Access Compliance Report

Public Rights-of-Way

(Curb Ramps)

Intersection ID: 8226	Main Street: CATHERINE_SIMMONS_AV	Cross Street: CUSTER_ST	Location: SE
ADA ID: F8340F4BAE3D	Ramp Type: BlendTrans2	Initial Pass/Fail: Fail	Overall Compliance: No
Codes/Mitigation Info/Possible Solution		Field Measurements/Component Compliance	
Severity Score: 12.5

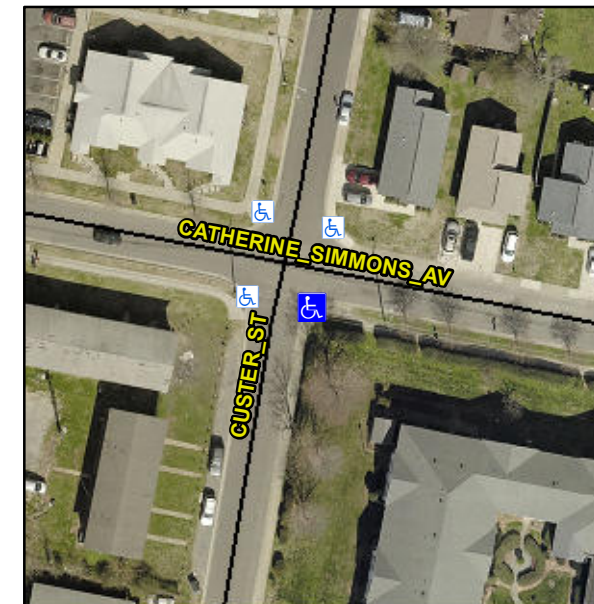
Not Found, R304.5.3

Compliance	Description	Data	Compliance	Description	Data
N/A	Ramp Length (in)	61.5	Yes	BlendTrans Slope (%)	4.0
Yes	Ramp Width (in)	98.0	No	BlendTrans XSlope (%)	5.5
N/A	Flare Type LT	N/A	N/A	Flare Type RT	N/A
N/A	Flare Slope LT (%)	N/A	N/A	Flare Slope RT (%)	N/A
N/A	Flare Traversable LT?	N/A	N/A	Flare Traversable RT?	N/A
N/A	Landing Length (in)	N/A	N/A	DWS Provided?	N/A
N/A	Landing Width (in)	N/A	N/A	DWS Contrast?	N/A
N/A	Landing Slope (%)	N/A	N/A	DWS Length (in)	N/A
N/A	Landing X Slope (%)	N/A	N/A	DWS Full Width?	N/A
N/A	Landing Curb? (Y/N)	N/A	N/A	DWS Offset (in)	N/A
N/A	Shared Landing?	N/A			
N/A	Gutter Ponding?	N/A	N/A	Gutter Slope (%)	N/A
N/A	Gutter Lip Ht (in)	N/A	N/A	Gutter X Slope (%)	N/A
N/A	Painted X Walk1?	No	N/A	Painted X Walk2?	No
	X Walk 1 Direction	To N		X Walk 2 Direction	To W
	X Walk 1 Width (in)	N/A		X Walk 2 Width (in)	N/A
	X Walk 1 Slope (%)	3.1		X Walk 2 Slope (%)	2.5
	X Walk 1 X Slope (%)	1.0		X Walk 2 X Slope (%)	4.7

N/A	Ramp inside XWalk1?	N/A	N/A	Ramp inside XWalk2?	N/A
	Road Slope (%)	2.5		Clear Space?	N/A
	Road X Slope (%)	5.9	N/A	Clear Space to XWalk (in)	N/A
N/A	Any Obstructions?	N/A	N/A	Storm Grate/Utility Hazard?	N/A
	Obstruction Type			Storm Grate/Utility Type	
		N/A			N/A
			Yes	Surface Condition? (G/P)	Good
			No	Curb Slope (%)	24.2

Remove & Replace Curb Ramp With Two New Directional Ramps or Equivalent.
